APPLICATION TO THE RESIDENTIAL DESIGN
AND COMPATIBILITY COMMISSION (RDCC)

GENERAL MODIFICATION WAIVER

STREET ADDRESS: 4107 Avenue G

I would like to request a waiver for FAR habitable
attic from the allowable 40%, which is 2,595 sf.
to 45%, which is 2,920 sf.

MARSHOT-KEYLEY RESIDENCE 10000 Aurora, Illinois 60015	DATE	01-04-2019	REVISION SET	SHEET TITLE ELEVATIONS & BUILDING SECTIONS	SHEET A2.1
	DESIGNED BY: C.D.

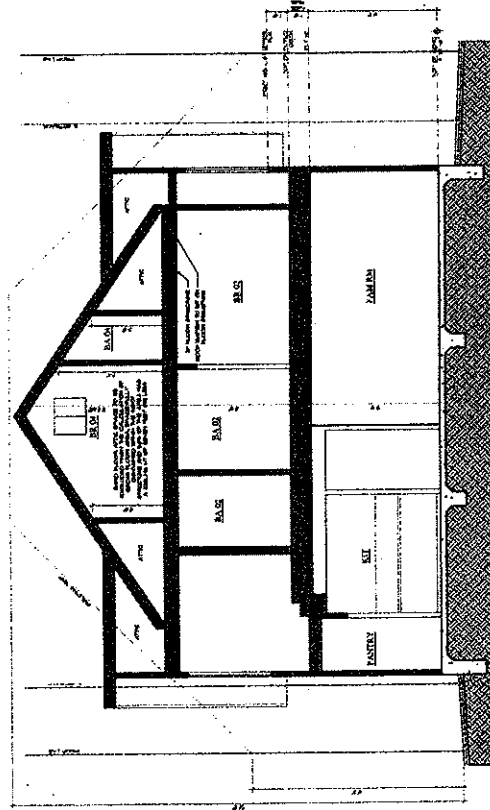
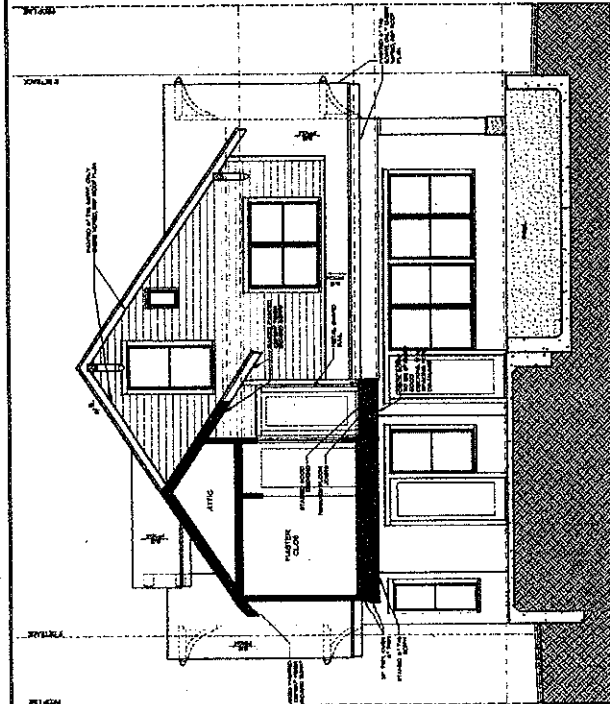
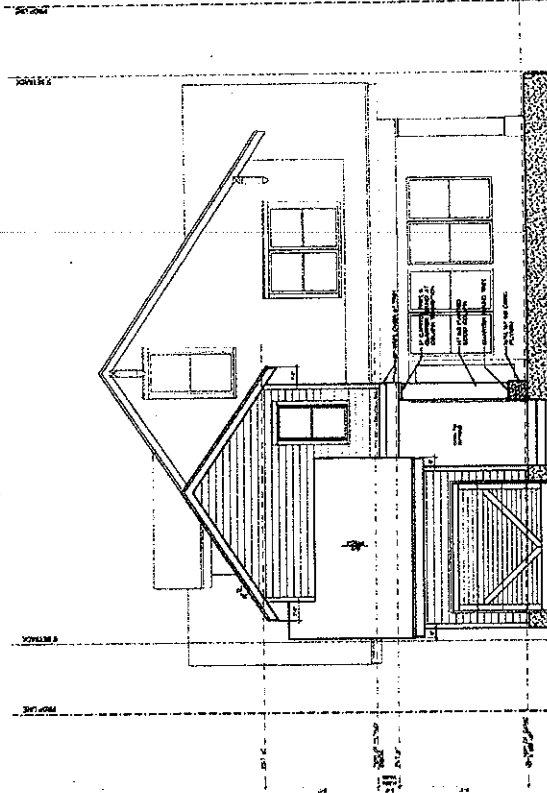
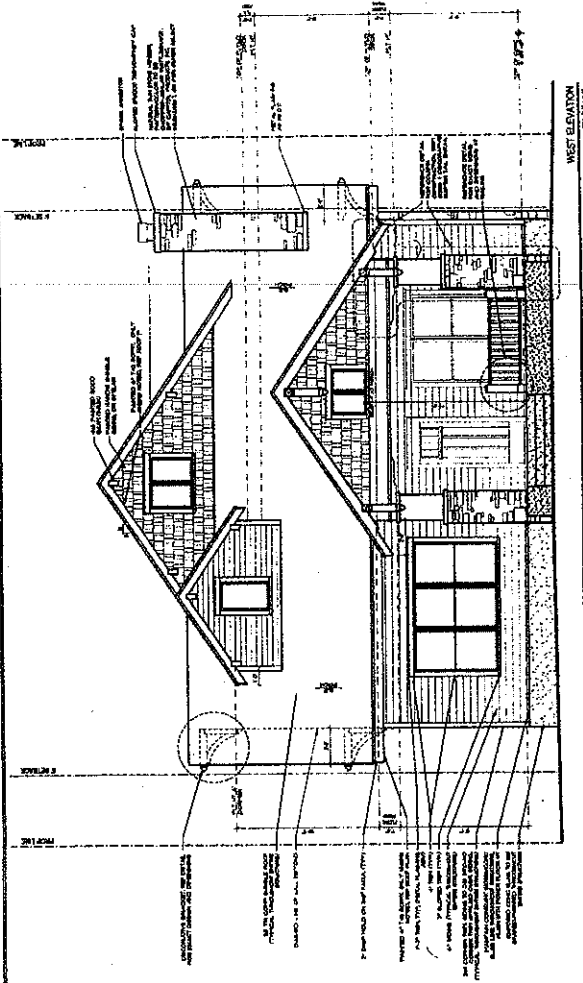
Provide more moulded detail at front porch railing.
